# ADDENDUM 1

PROJECT NAME: MEDICAL CENTER INTERSECTION IMPROVEMENTS – PHASE X

DATE: 08/16/17

PROJECT NO.: **40-00309A**

100 % SUBMITTAL	PROJECT NO.:	5241-46	DATE:	8/7/2017
DRWN. BY: JG	DSGN. BY: JG	CHKD. BY: LR	SHEET NO.:	15

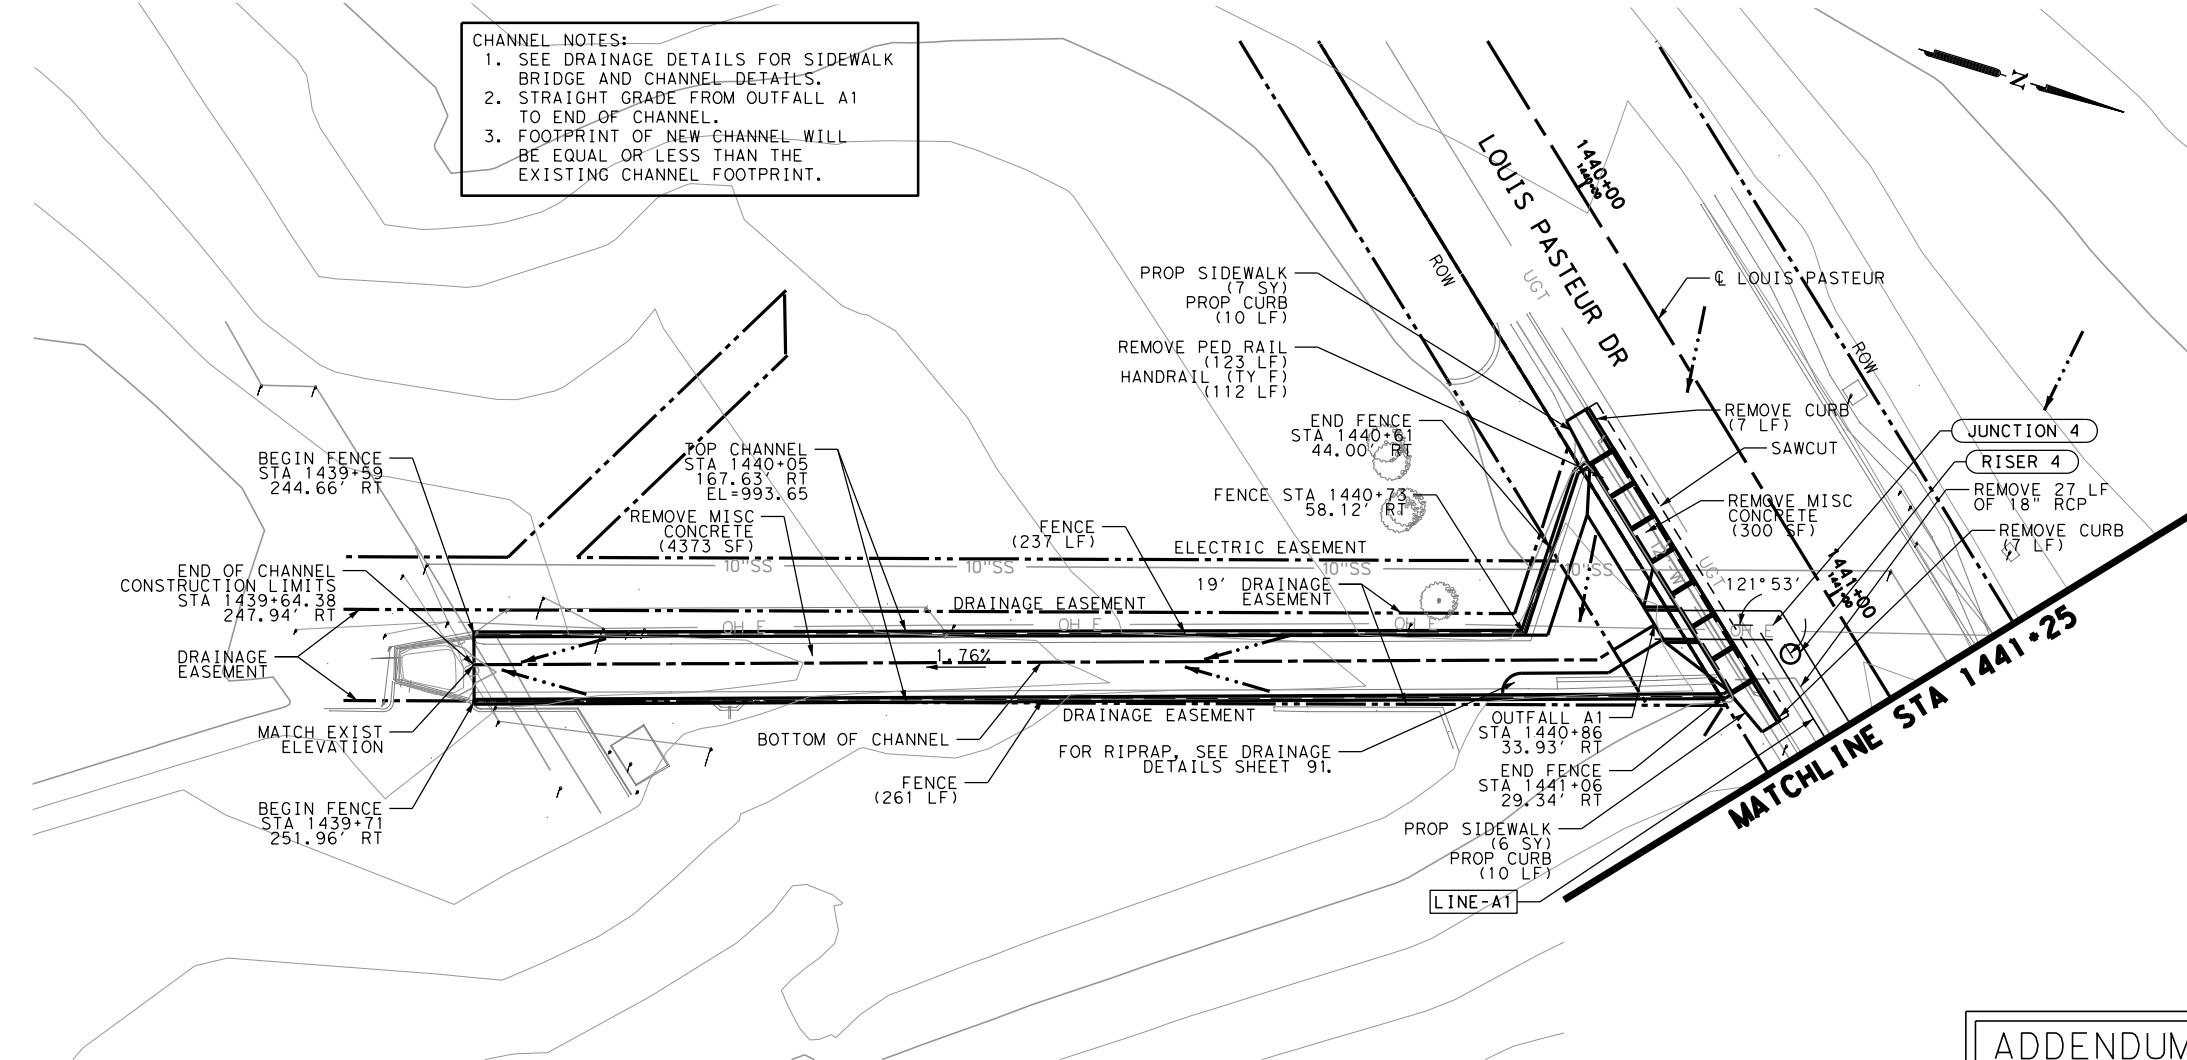
- Revised quantity for item 551.1.
  - Item numbers for landscaping changed as stated above.
  - Removed 680.its01 to 680.its08 from the quantities.
- Replace Sheet 15 “Traffic control plan narrative and special notes” with Addendum 01 “Traffic control plan narrative and special notes”.

- Special note was added in regards to WellMed parking lot construction timeline.
- Replace Sheets 83-89 “Storm Drain Plan and Profile” with Addendum 01 “Storm Drain Plan and Profile”.

100 % SUBMITTAL	PROJECT NO.:	5241-46	DATE:	8/16/2017
DRWN. BY: JG	DSGN. BY: JG	CHKD. BY: LR	SHEET NO.:	83

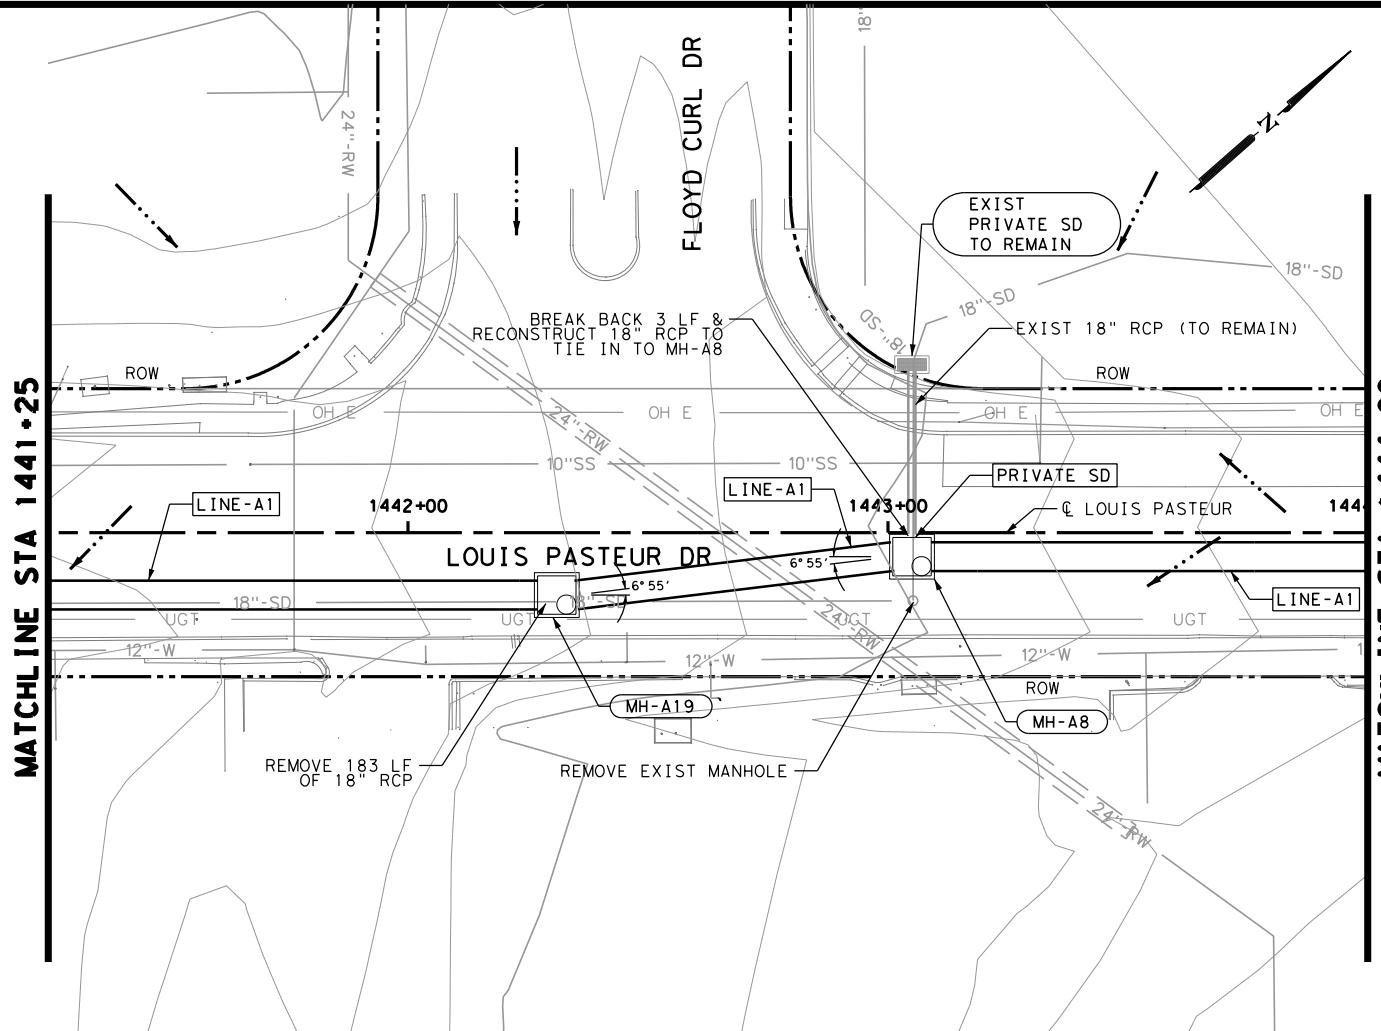
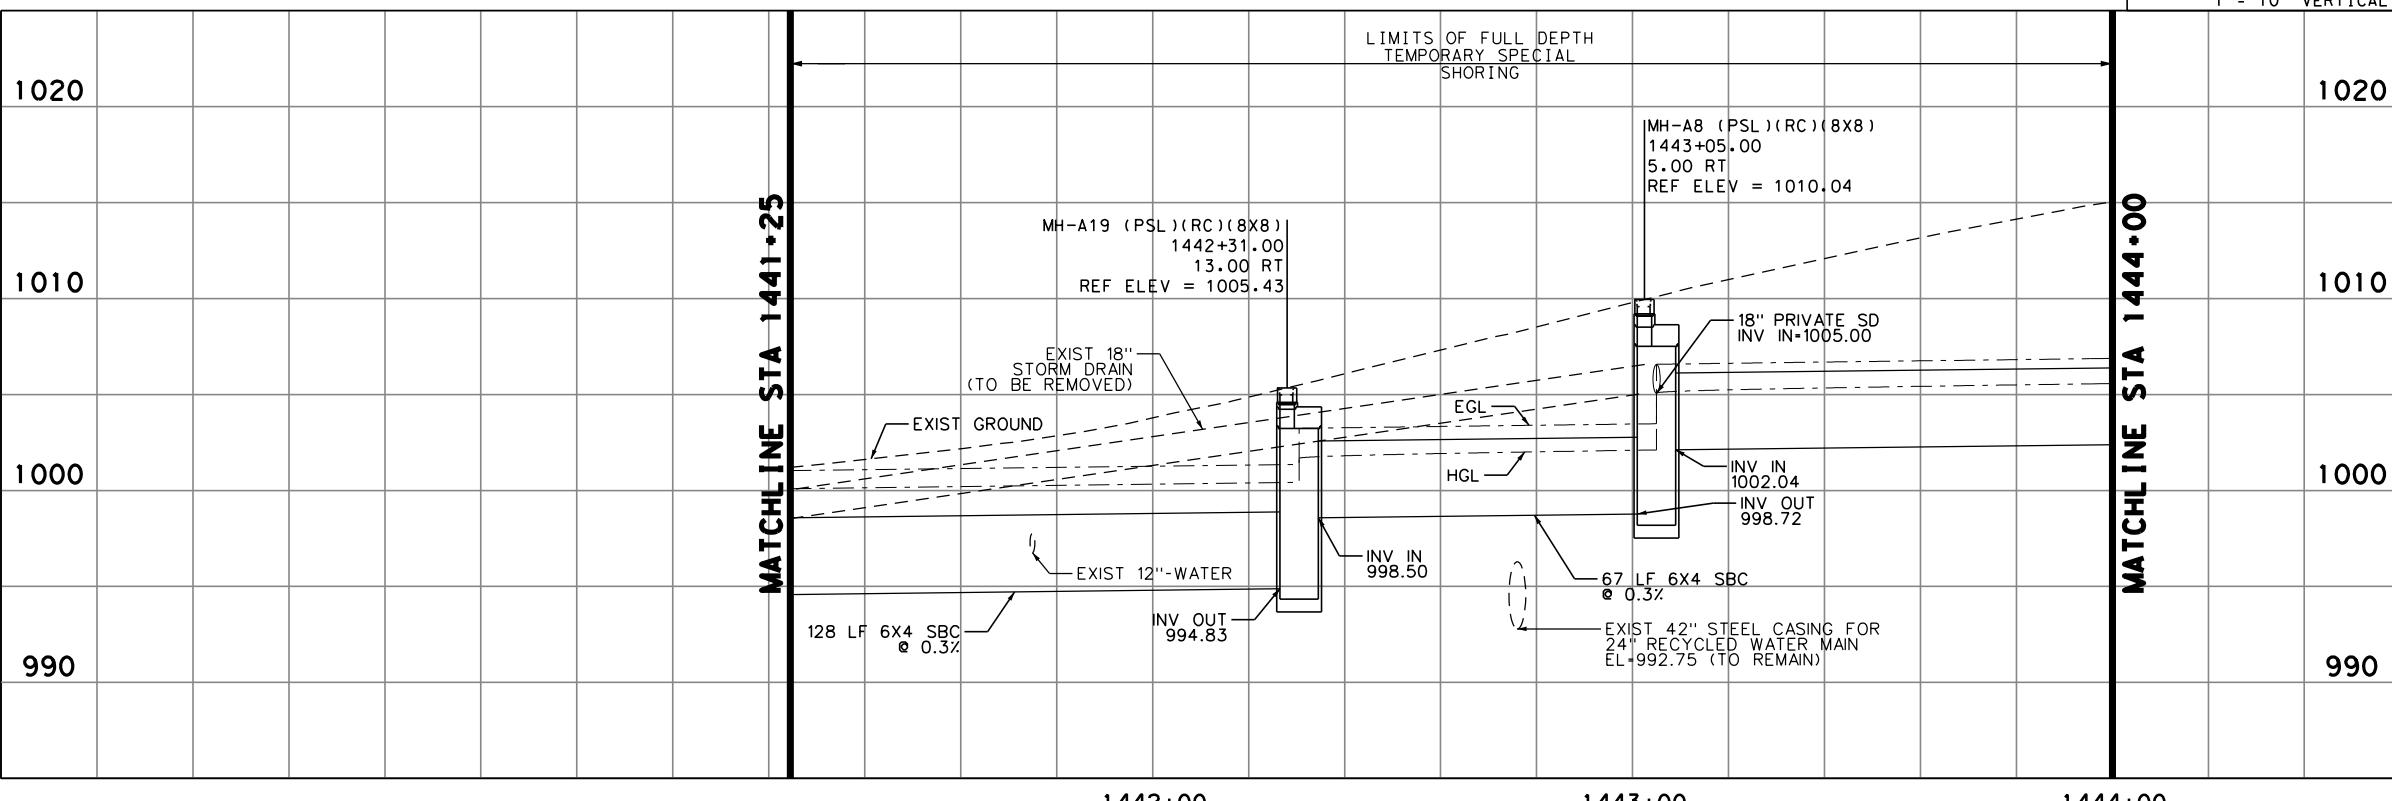
- Included callouts to describe limits of Temporary Special Shoring.
- Replace Sheet 148 “Traffic Signal Summary” with Addendum 01 “Traffic Signal Summary”.

*Response: Temporary shoring is for main drainage trunk line and is called out in addendum No. 1 drainage plans. Contractor to choose their method of shoring approved by an engineer.*

**MEDICAL CENTER PHASE X**  
**LOUIS PASTEUR RIGHT TURN LANE**  
**TRAFFIC SIGNAL PLAN**  
**SUMMARY**

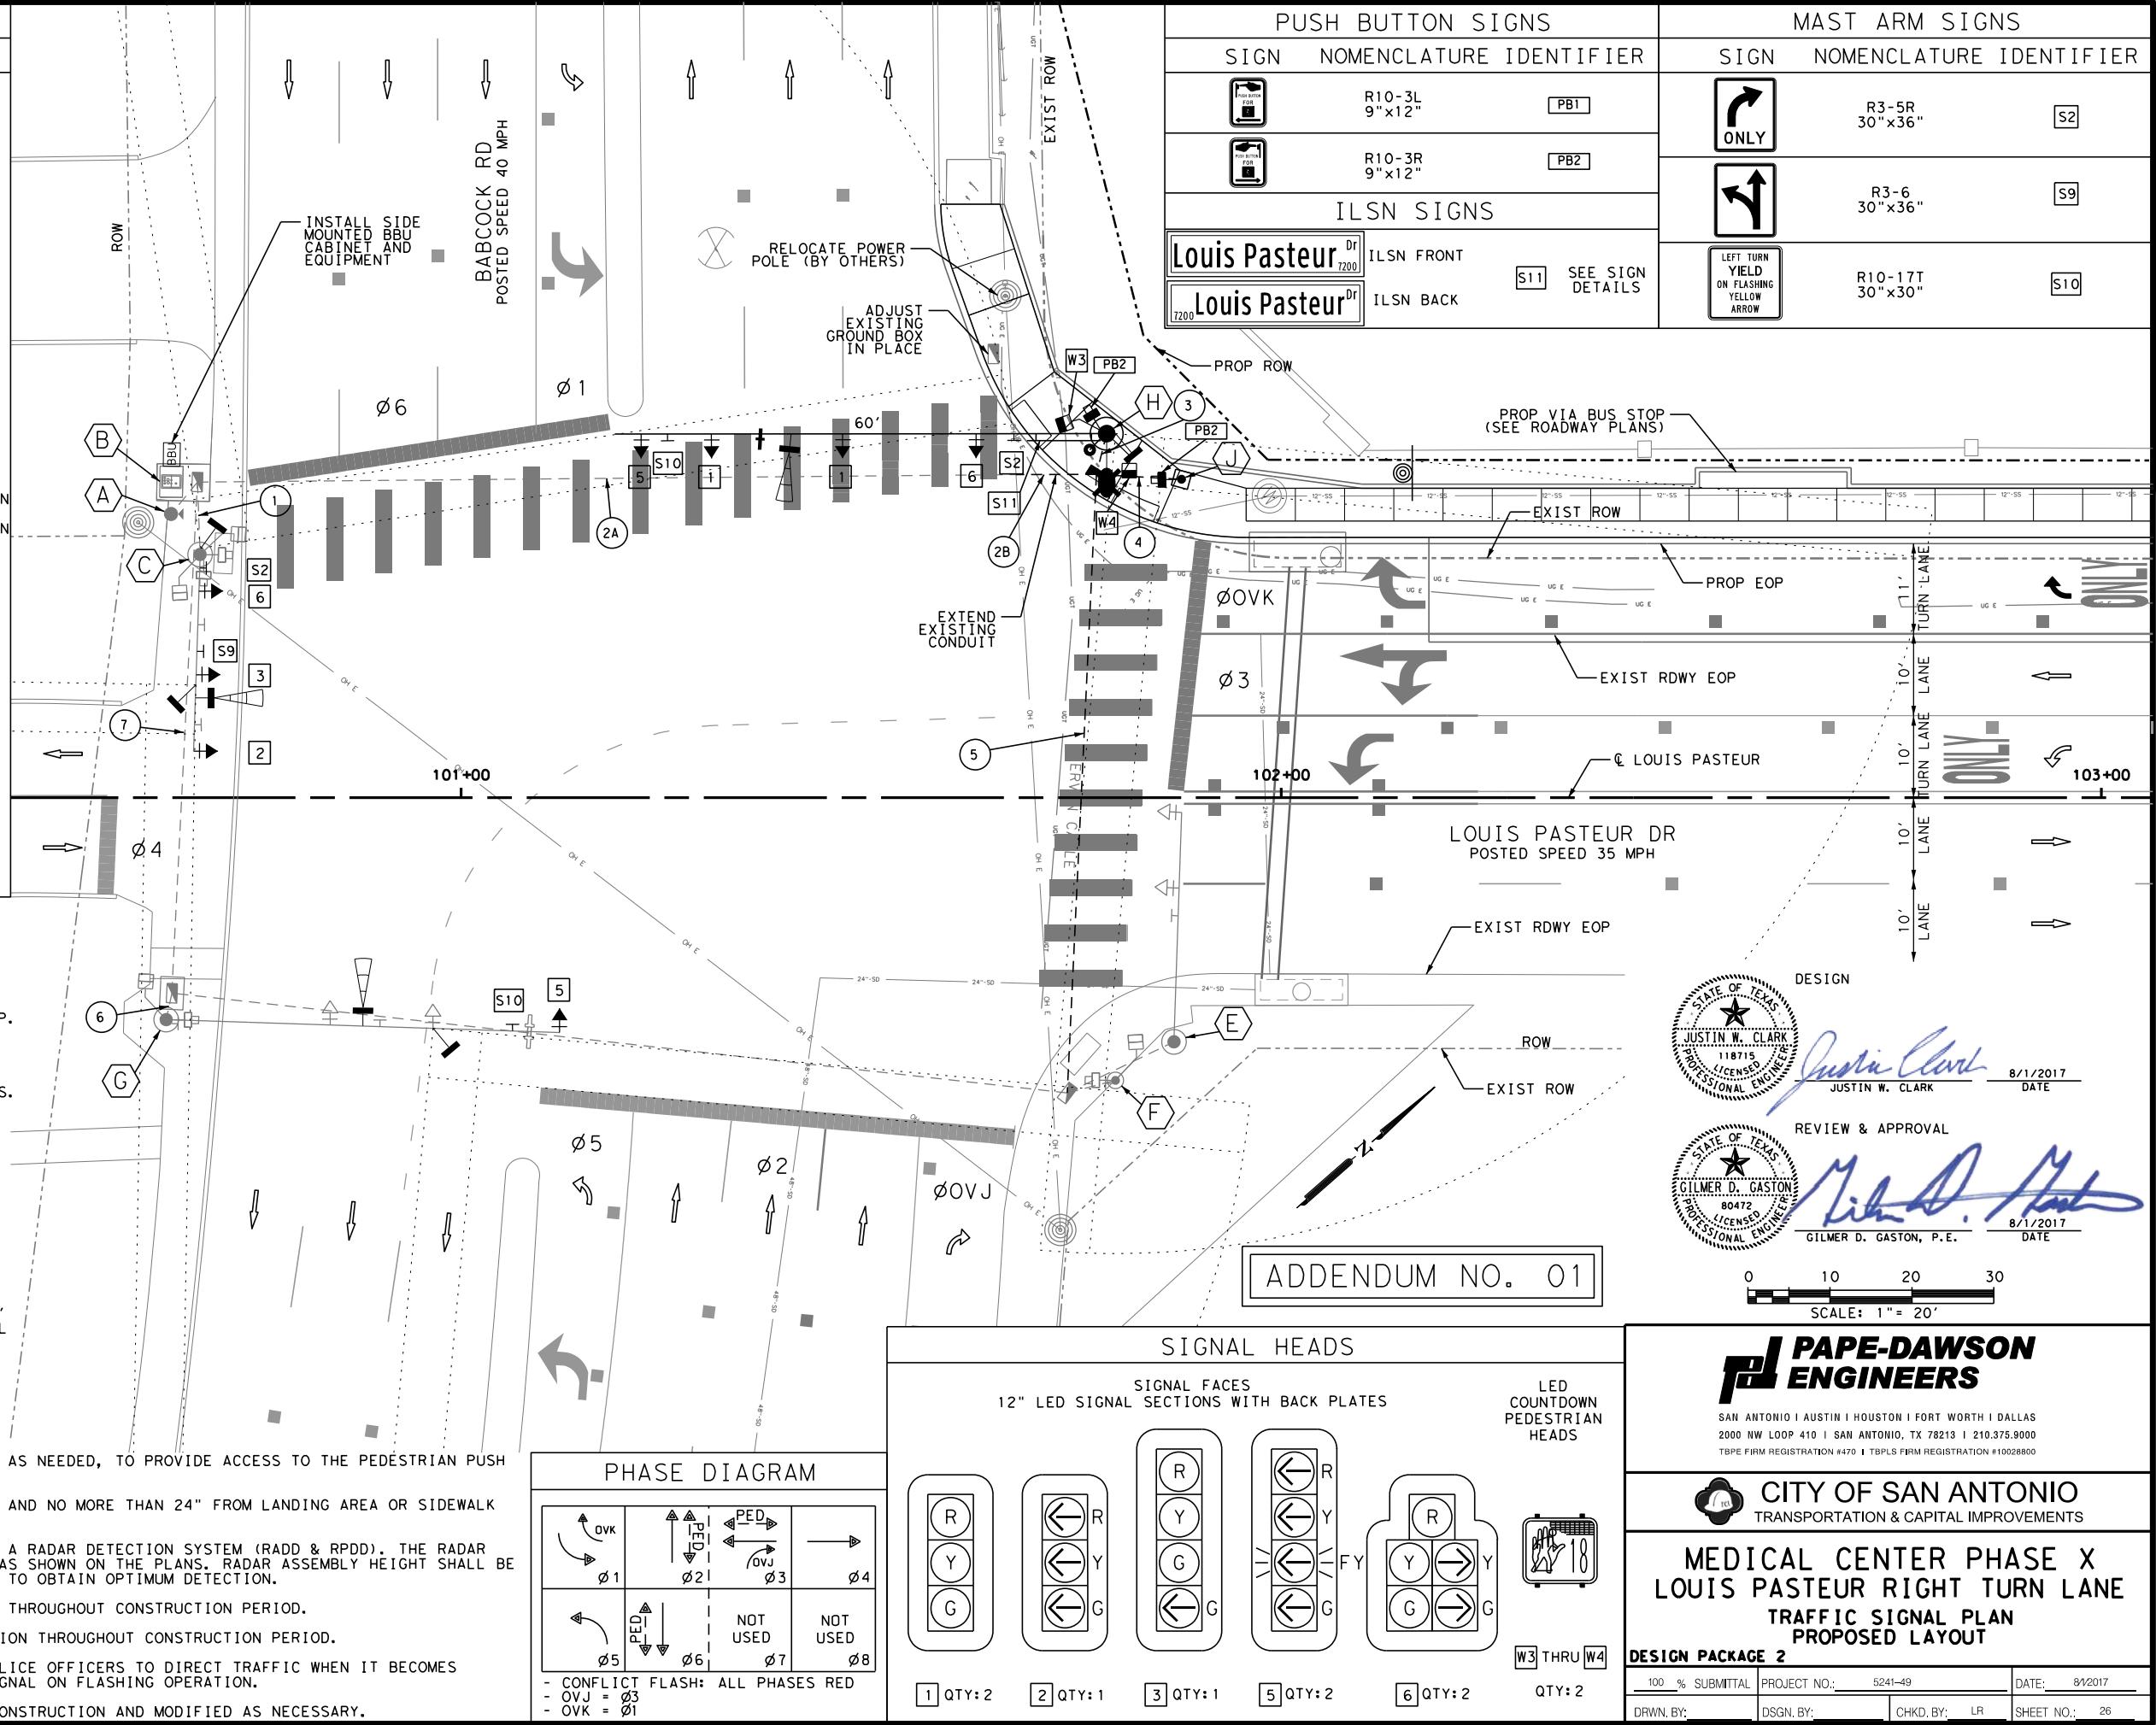
- Replace Sheet 4 “Estimate and Quantity” with Addendum 01 “Estimate and Quantity”.
  - Removed Item 0508-2001 from the quantities.
  - Item numbers for landscaping changed.
  - Removed 680.its01 to 680.its08 from the quantities.
- Replace Sheet 26 “Traffic Signal Plan Proposed Layout” with Addendum 01 “Traffic Signal Plan Layout”.
  - Removed note regarding installation of LTE communication equipment.
- Replace Sheet 27 “Traffic Signal Plan Conduit & Conductor Schedule” with Addendum 01 “Traffic Signal Plan Conduit & Conductor Schedule”.
  - Removed installation of LTE equipment from controller cabinet (Labeled as B on plans)
- Replace Sheet 29 “Traffic Signal Plan Summary” with Addendum 01 “Traffic Signal Plan Summary”.
  - Removed items 680.its01 to 680.its08 from the table.
